# Safety Recall

## N232431480 Front Wheel Hub Bolts May Fracture

**Revision:** 01

**Revision Description:** This bulletin is being revised to add the customer letter. Please discard all previous copies of N232431480.

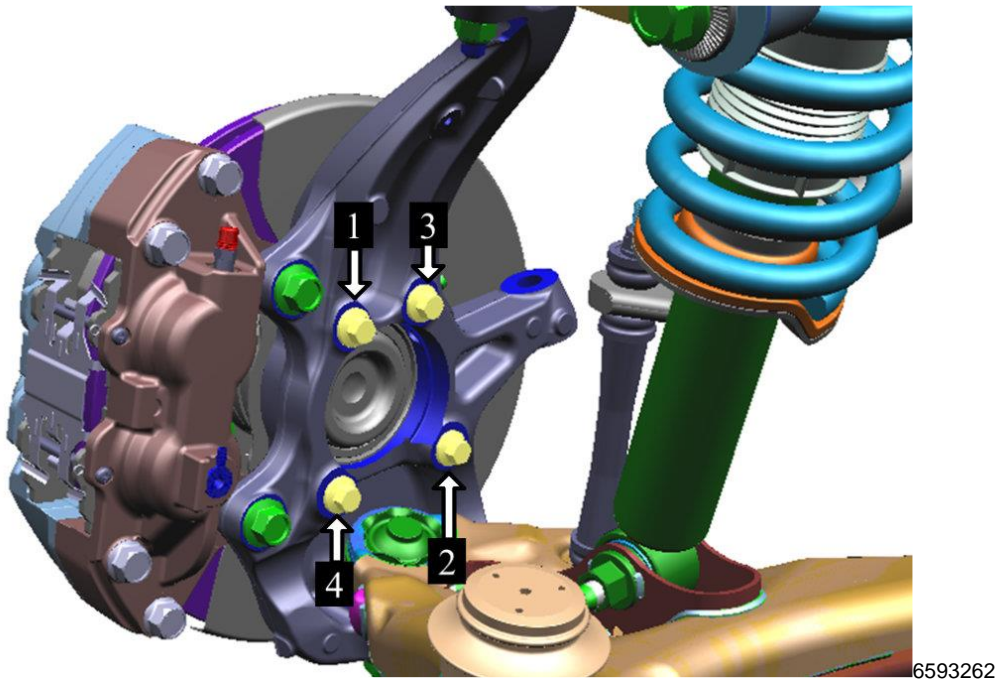
**Important:** Remove and replace the Front Wheel Hub Fasteners one at a time.

2. One bolt at a time, remove each Front Right Hand Side Wheel Hub Fastener and replace with NEW Front Wheel Hub Fastener hand tight.

**Caution:** This vehicle is equipped with torque-to-yield or single use fasteners. Install a NEW torque-to-yield or single use fastener when installing this component. Failure to replace the torque-to-yield or single use fastener could cause damage to the vehicle or component.

**Note:** Torque each fastener in sequence as the graphic above illustrates.

3. Tighten in sequence as illustrated in the above each Front Right Hand Side Wheel Hub Fastener to **130Nm (96 lb ft)** then torque each Fastener in sequence as illustrated in the above an additional **90-105 degrees**.
4. Repeat Steps 2 and 3 for the Left Hand Side Front Wheel Hub Fasteners.
5. Lower the vehicle. Refer to *Lifting and Jacking the Vehicle* in SI.
